**NOTICE OF A PUBLIC HEARING BEFORE
THE CITY COUNCIL ON AN APPEAL OF THE
PORTLAND DESIGN COMMISSION**

CASE FILE: LU 16-100496 DZM MS (Block 290)
WHEN: Thursday, October 12, 2017 @ 2pm
WHERE: COUNCIL CHAMBERS, 1221 SW FOURTH AVENUE

Site Address: BLOCK 290 - 1417 NW 20th Avenue

Case Type: DZM MS – Design Review with Modifications and *potential* Master Plan Amendment

SITE PLAN

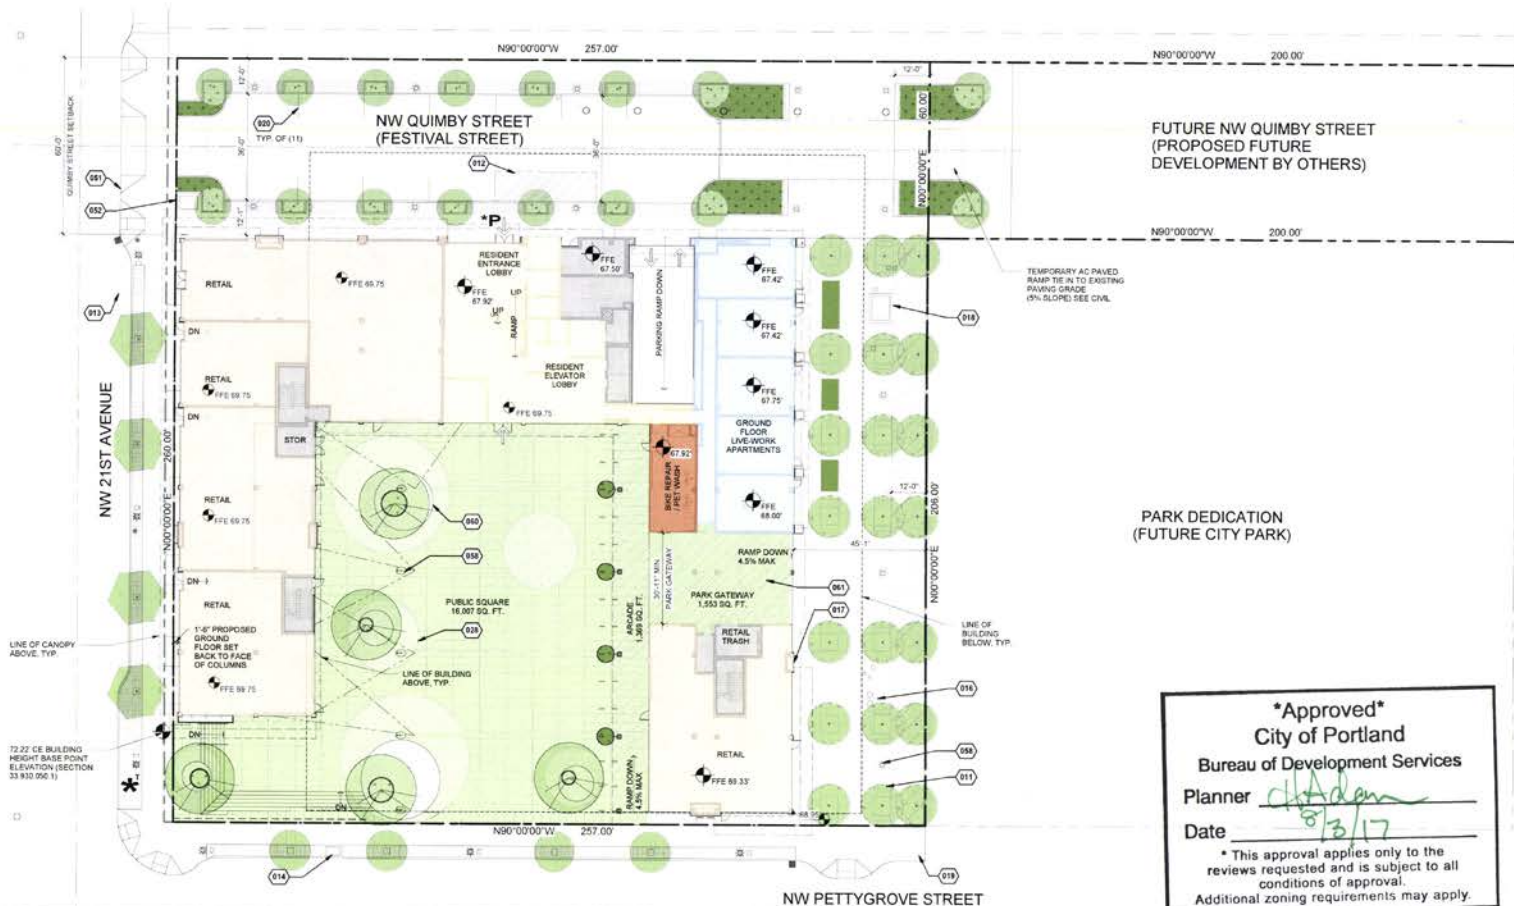
**see Cond. J+K*

- J. The middle round bench in the middle of the square shall be eliminated. The benches shall be made of Ipé wood.
- K. Four additional benches shall be added to the north-south pedway (for a total of 8 benches), with some oriented perpendicular to the pedway.
